Staff Report and Decision Administrative Conditional Use Permit

Project: North Beach Inn ACUP Major Revision (Bucklin Court)

Planning File Number: 16 01847

Type of Application: Administrative Conditional Use Permit – Major Revision

1 BUCKLIN COURT SHORELINE VARIANCE COMPARISON PLAN 11.23.15

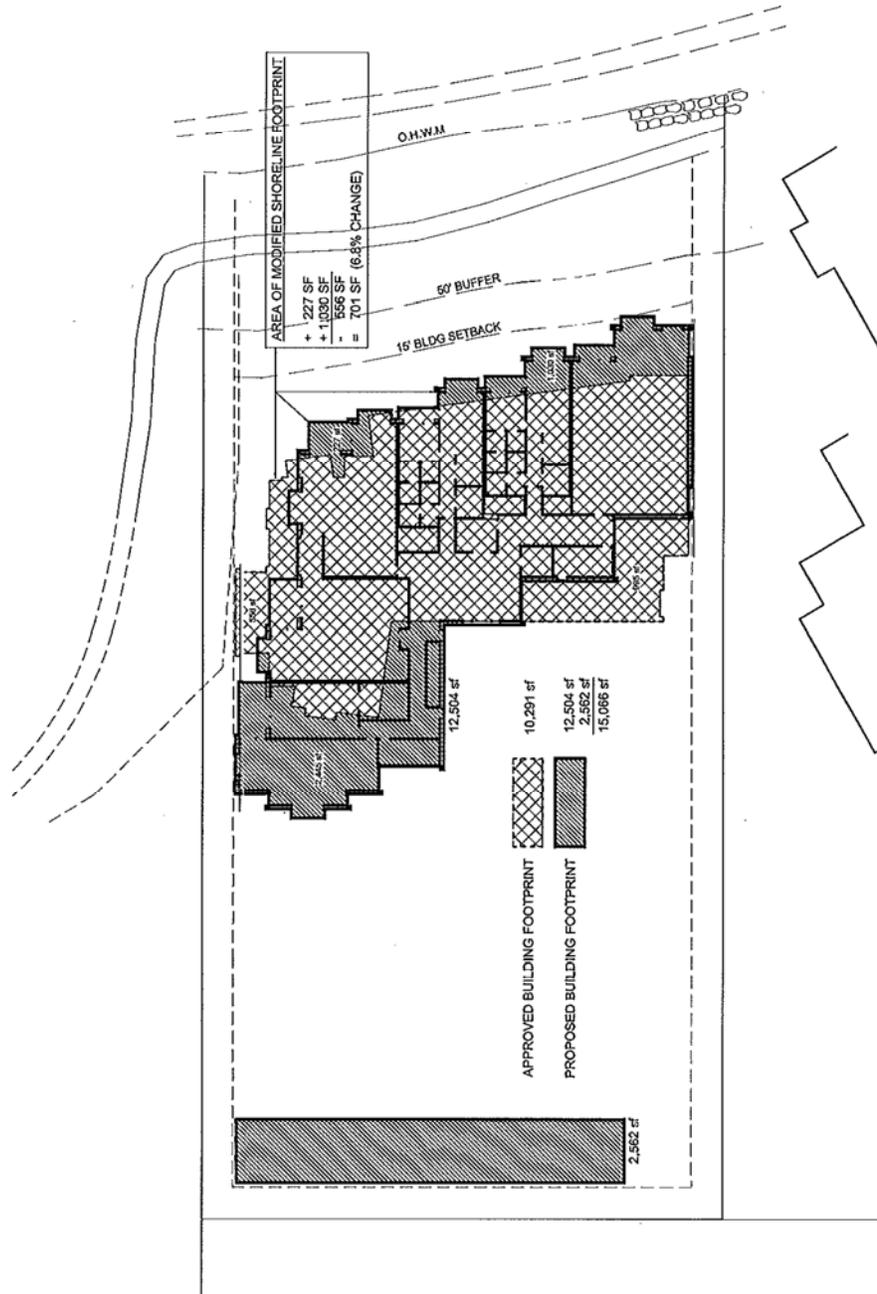
22. Fire flow for the proposed structure requires 3 hydrants, only 2 are shown on the plans. Please provide an additional hydrant within 600 feet or provide a plan showing an existing hydrant within 600 feet of the structure. Hydrants shall be shown on the SDAP.

(See Attached Site Plan Below)
